City of Portland Bureau of Development Services

Staff Presentation to the Design Commission

EA 14-208933 DA
Front 17

ground floor plan level 1

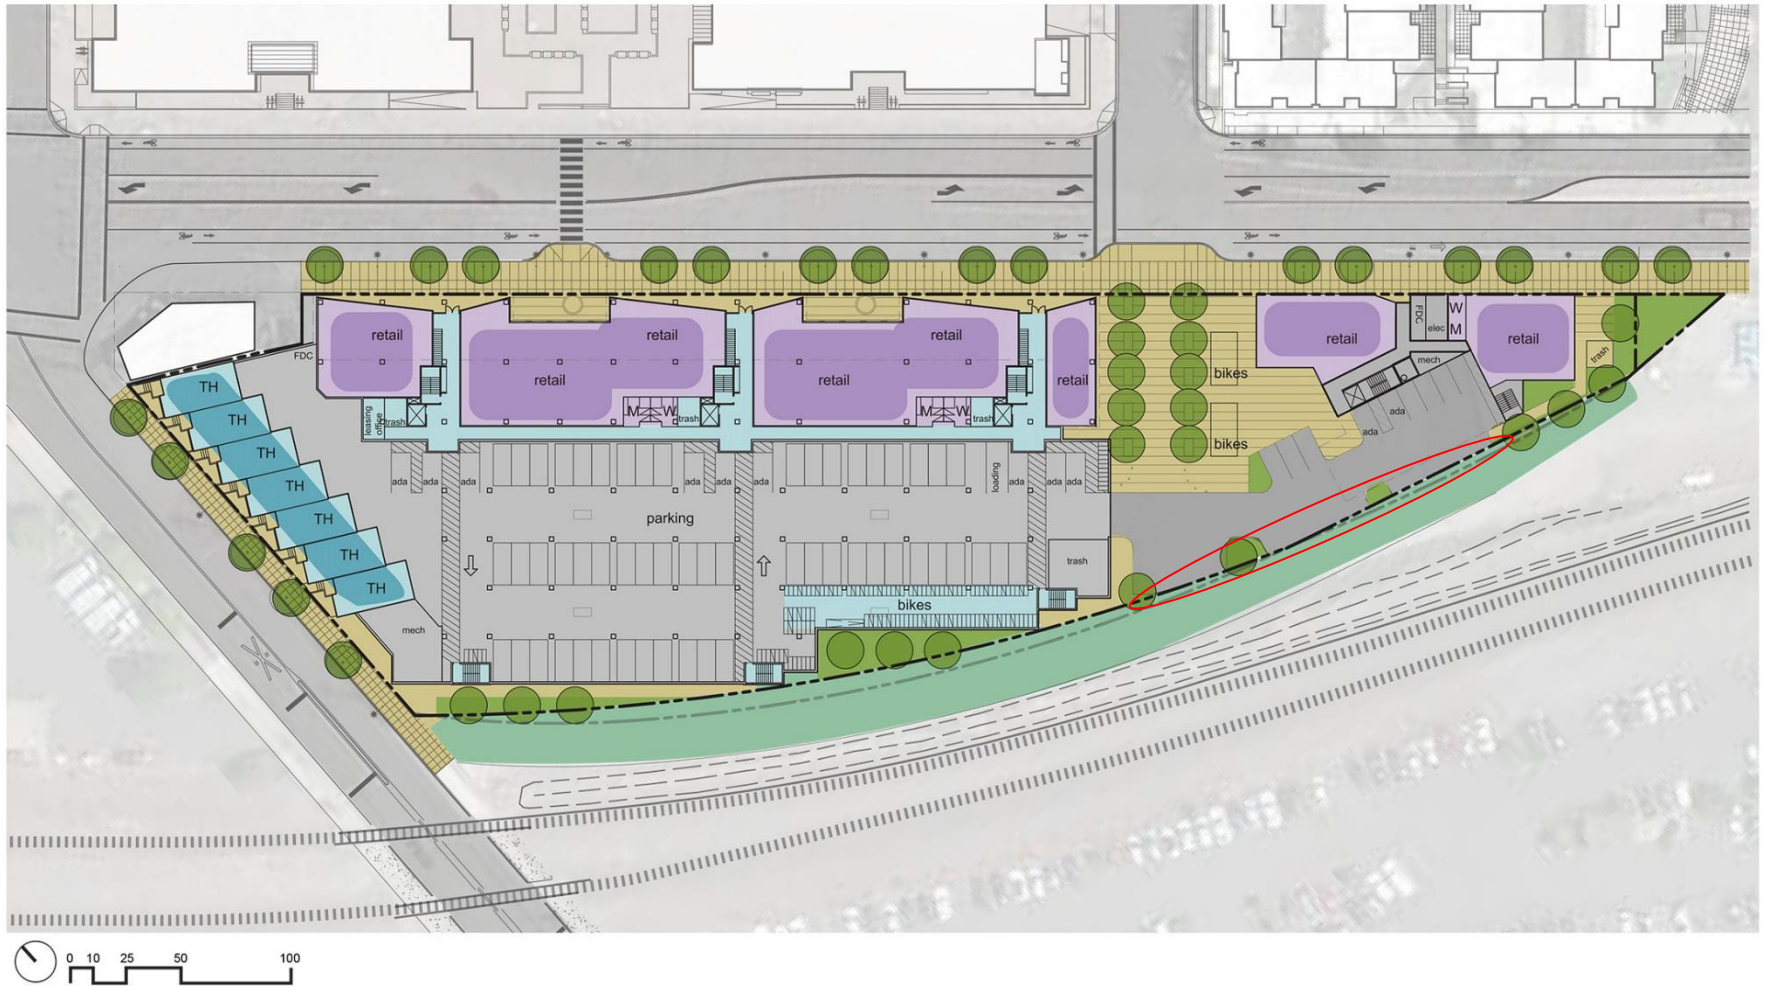
Interface between ped areas and surface parking at driveway/plaza, pedestrian access to back/Terminal side?

Massing in relation to Riverscape, large plinth/ground floor wall along Front, adding further breaks to reflect 200' block structure, bringing podium green space down

South side 'alley' treatment, blank walls versus more engaged pedestrian experience, discussion of any improvements and what remains between site and railroad, walkways, etc.

cladding options multifamily buildings

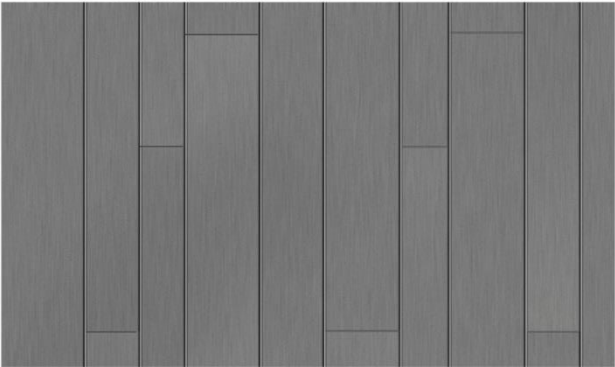
- **Design and Materials** (material choices, proportional relations between double-height ground floor of apartment blocks and the upper stories, clarification on specific materials, e.g. is it wood or Okoskin? etc.); and
